Other Regulations - Regulation No. 86 (Installation of lighting and light-signalling devices for agricultural tractors)

Proposal for the 01 series of amendments to Regulation No. 86 (Installation of lighting and light-signalling devices for agricultural vehicles)

Submitted by the Chairs of the Informal Working Group on Agricultural Vehicles Lighting Installation*

Direction-indicator lamps - Geometric visibility

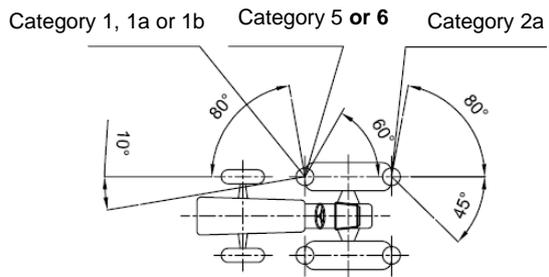
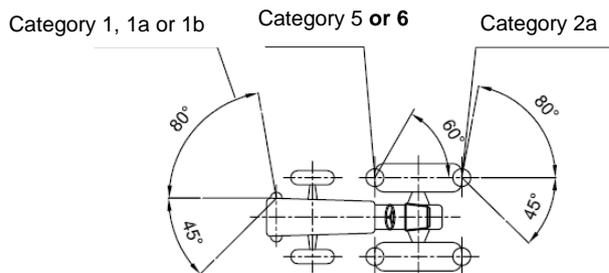
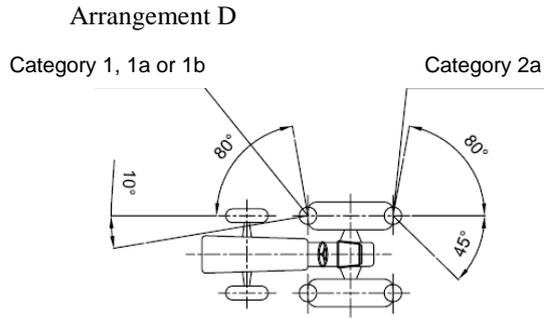
Annex 5, amend to read:

For rear direction indicators, the horizontal inward angle may be reduced to 30° if the shape of the bodywork makes it impossible to reach 45°."

The value 10° given for the inward angle of visibility of the front indicator may be reduced to 3° for vehicles with an overall width not exceeding 1,400 mm.

Figure 1.
Basic standard area

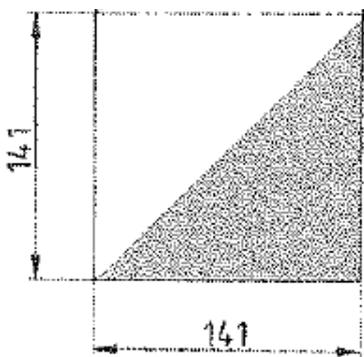
Insert a new Annex 6, to read:

1. Dimensions, arrangement, number and minimum reflecting surface
 - 1.1. Signalling panels and signalling foils shall have the following dimensions:
